©Kawasaki Motors Corp 1974 Printed in USA

PROBLEM:

H1 with original H.T. wiring

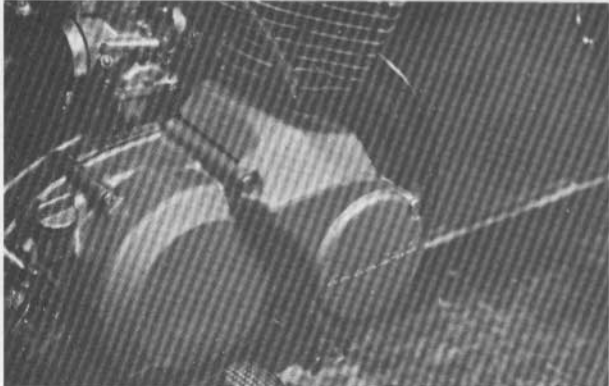
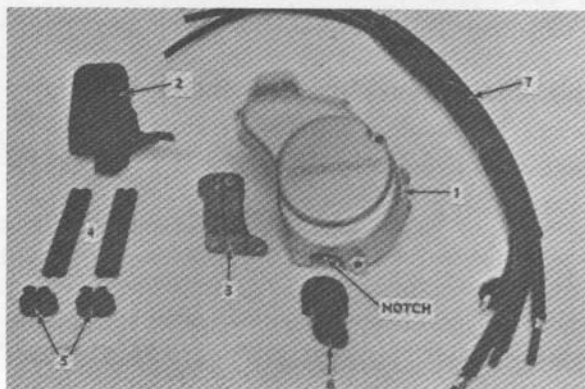
The spark plugs generally are not the cause of the problem. We have found the high tension wiring leaks electricity to adjoining metal engine parts under high voltage loads. New spark plugs require less voltage to fire because the electrodes have sharp edges. As the plugs are used, these sharp edges are rounded off by high energy discharge and erosion from heat and chemical action in the combustion chamber. Consequently, they require an increasing amount of voltage to fire as mileage accumulates. Worn spark plugs, over-rich oil pump settings, or incorrect fuel mixtures demand more voltage from the ignition system to fire the spark plugs. These conditions "back up" the voltage in the secondary wiring until it jumps through the H.T. cord insulation to an inviting engine ground rather than fire the plugs.

KAWASAKI has developed a set of high tension components which, after thorough testing, has proven completely reliable and eliminates the insulation leakage problem. The purpose of the new components is to re-route the H.T. cords so they are a safe distance from metal engine grounds like the oil pump, oil pump cover, engine cover, cylinders, carburetors, etc. Additionally, the type of H.T. cord has been changed from DAIICHI brand to Belden, a better-insulated cable.

The new H.T. components were incorporated on H1's after Engine KAE-08800. The drain grommet was not used until KAE-11300, so on units from KAE-08800 to KAE-11300, the oil pump cover is not notched for the drain grommet.

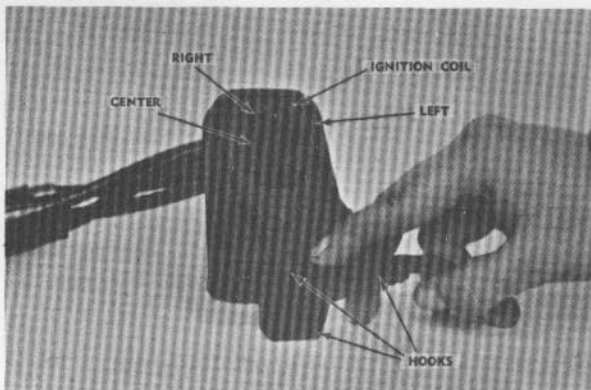
To save time, use the photo above for inserting the cords in the grommet. The bottom cords should protrude 1" more than the top ones.

To keep water from entering, make sure the bottom of the grommet is hooked onto the crankcase. Route the H.T. cords over the RH carburetor, NOT between the carburetor and cylinder.

Jam the H.T. cords completely into the distributor cap sockets before installing the piercing screws.
